LETTER AND CONCURRENCE FROM MINNESOTA POLLUTION CONTROL AGENCY
REGARDING FIELD INVESTIGATION REPORT ANOKA COUNTY RIVERFRONT
PARKNIROP FRIDLEY MN
8/17/2000
MINNESOTA POLLUTION CONTROL AGENCY

RE: Naval Industrial Reserve Ordnance Plant Superfund Site

Modifications to the Report Entitled “Field Investigation Report at the NIROP and Anoka County Riverfront Park” (FIR), Dated April 2000

Figure 1 – Location of area of Fence Diagram

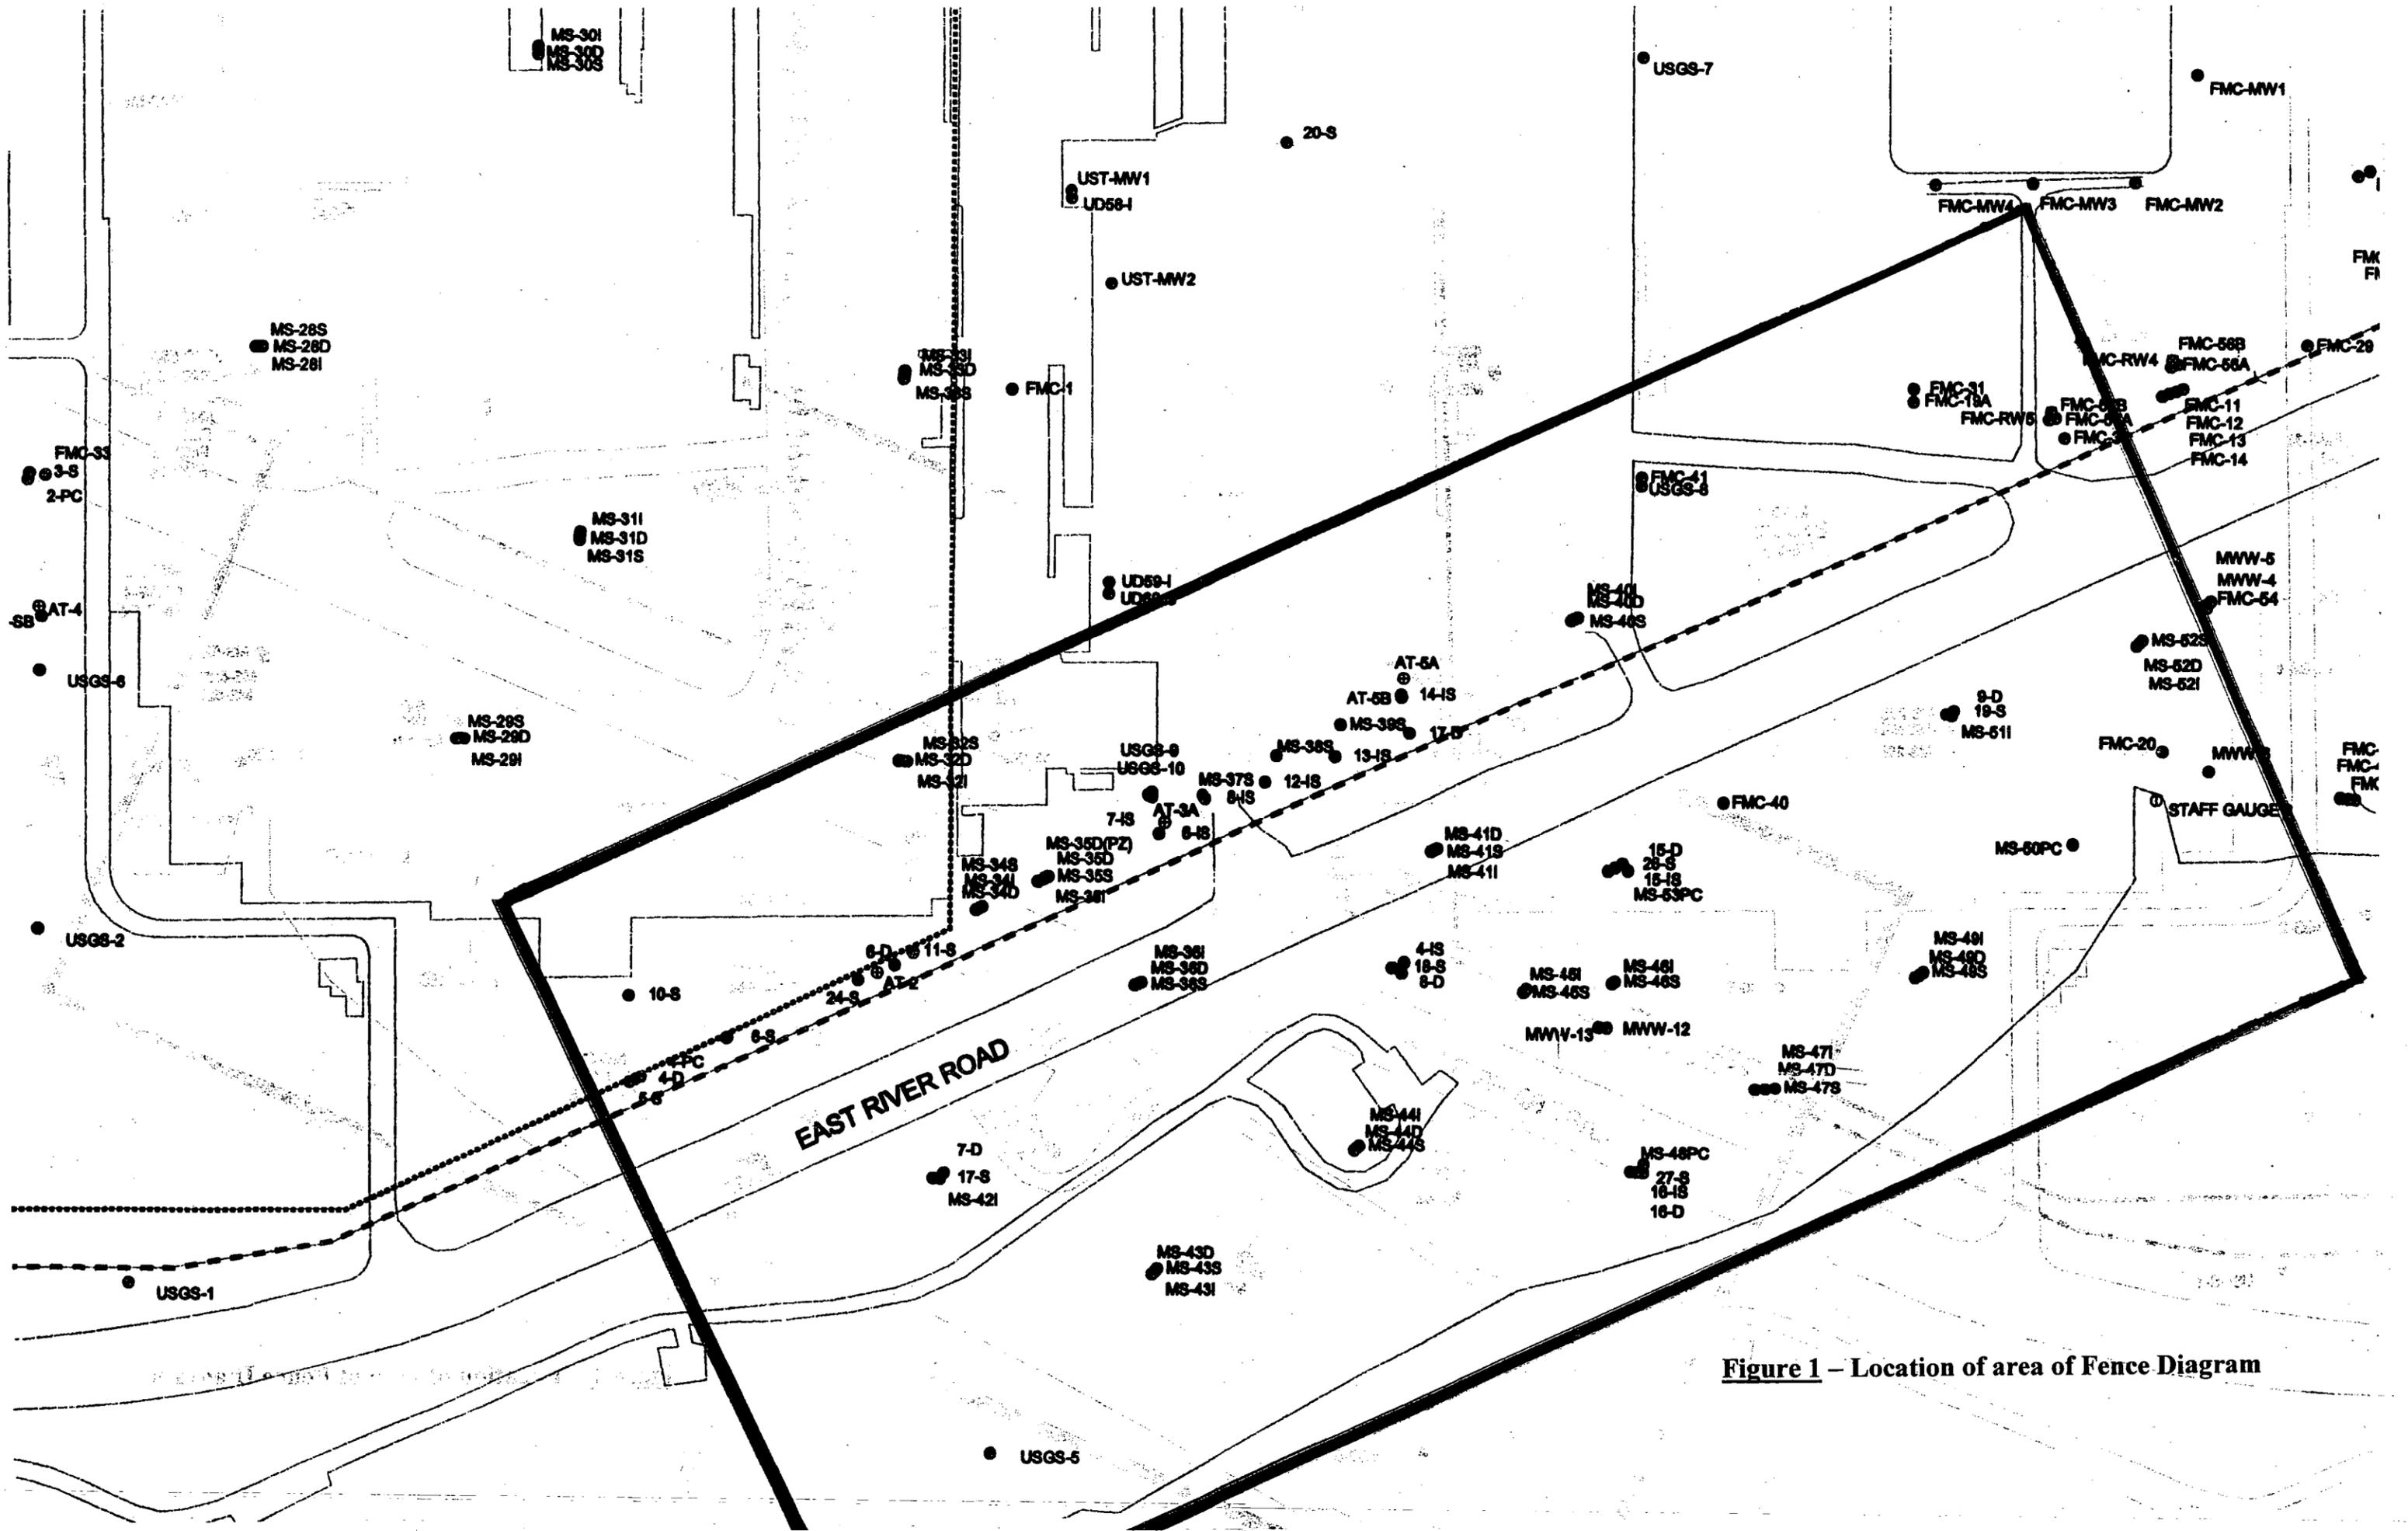
12. General Modification: Using lithologic logs from the wells located within the area shown on the attached site map (Figure 1), the MPCA staff requests that the Navy construct a geologic fence diagram of the site compliance line area and ACP. The diagram will be useful in visualizing the geology in the area to assist in evaluation of where potential ACP remedies may be applied to maximize remedial measures. The fence diagram will identify the location of permeable zones and low permeability zones and how these geologic conditions might effect the application and effectiveness of remedial options. The information can be used, for instance, to determine where reagents for enhanced biodegradation may be best applied and in predicting the path of ground water movement in ACP. The use of fence diagrams is a fairly commonly used tool to aid in visualization of geologic conditions.
